SERVICE DIRECTIVE BULLETIN 0080
Supercedes S.I.L. 132
Page 1 of 6

1. SUBJECT: Tail Rotor Drive Flex Couplings Mandatory Upgrade to (7) Plate Coupling, Inspection & Service Life
2. MODELS: All Models Equipped With Tail Rotor Flex Plate Couplings
3. EFFECTIVITY: Prior To The Next 25 Hour Inspection
4. BACKGROUND:

Figure 1-Acceptable Limits for Bent Flanges

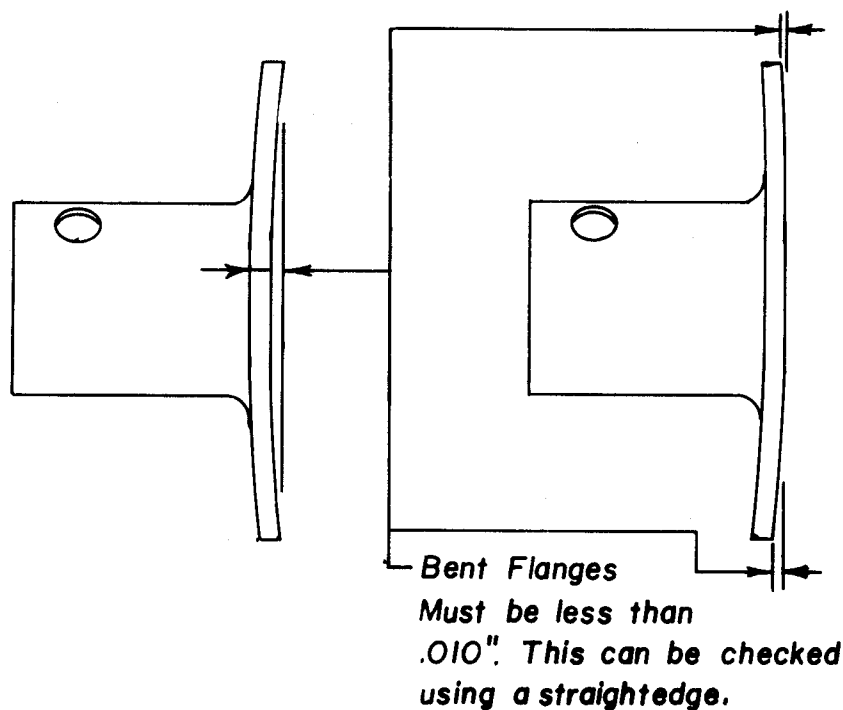
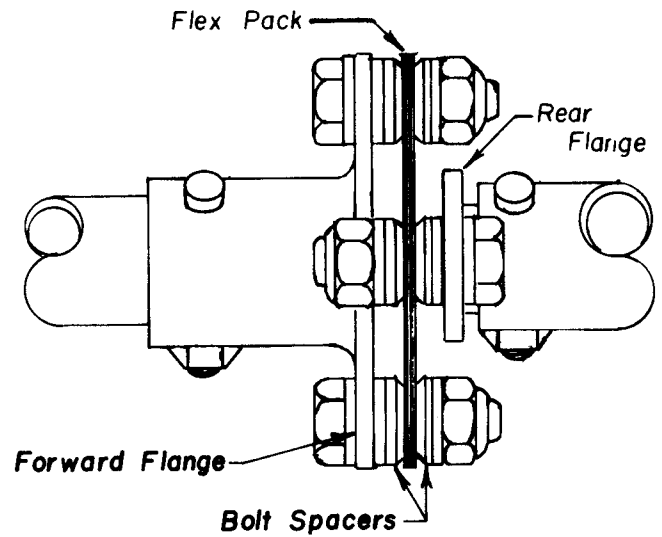
- 5.2 Upon removal of the (5) flex coupling, inspect the condition of the flanges which hold the flex pack. They must be flat within .010 inch as shown in Figure 1. Any flanges which are deformed beyond this limit must be replaced before further flight.

**Figure 2 - Acceptable Limits of Bowed Flex Packs.
NOTE: Tie-wraps eliminated for clarity.**

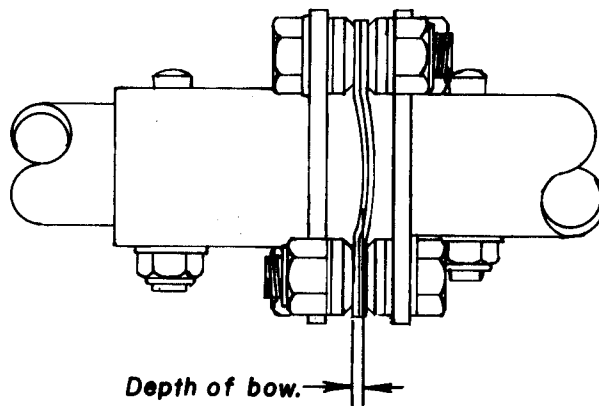
- 12.1.1 The bow, as measured in Figure 2, is less than .040 inch deep on the compression side and less than .020 inch deep on the tension side.

Depth of bow. →
**Must be less than .040" on compression
side and less than .020" on tension side.
Plates may be bowed in either direction.**

Figure. 3- Acceptable Limits of Flex Packs with Offset Bends.
NOTE: Tie-wraps eliminated for clarity.

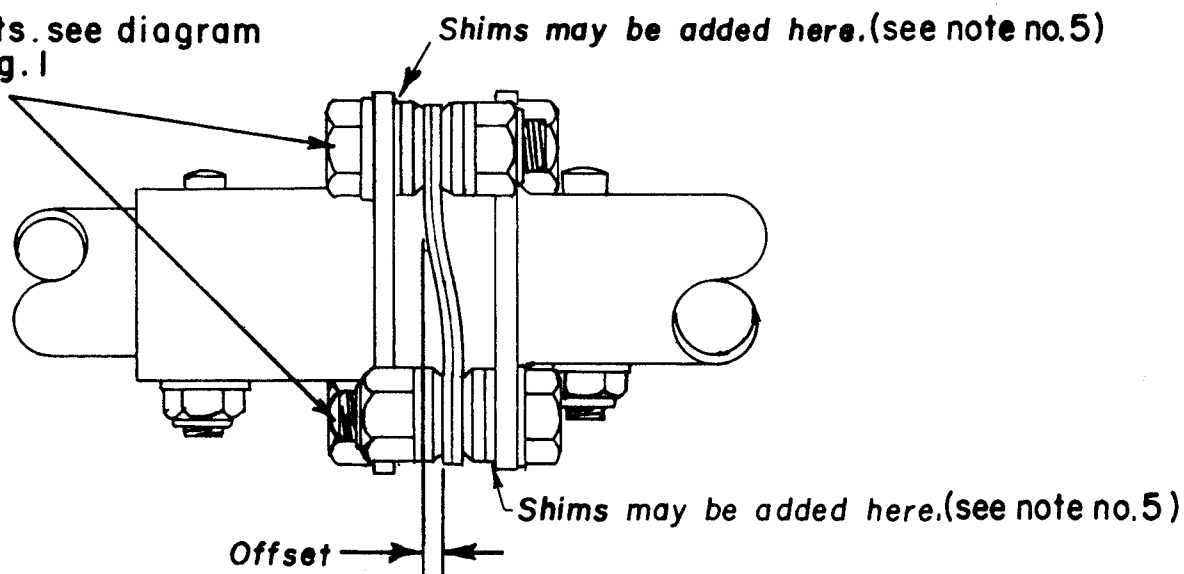
12.2 The second type of flex pack distortion typically encountered is an offset bend as shown in Figure 3. (Note that the bend in Figure 3 has been exaggerated for clarity.) This type of distortion usually occurs because the coupling halves are not running parallel with each other. This type of distortion is allowable only as long as the flex pack meets the following requirements:

- 12.2.1 The offset is less than .015 inch as shown in Figure 3.
- 12.2.2 The maximum difference in offset from side to side (one pair of bolts to the other pair) is less than .007 in.
- 12.2.3 The maximum allowable shim thickness is .072 in. not including beveled washers.

Must be less than .015" on both sides(see note no. 4). When the flex pack is replaced, shims may be added at the bolt spacers as indicated to align the new flex pack.

Torque bolts to 75 in. lbs.

CAUTION: Do not add shims or washers between the flex pack and the beveled washers.
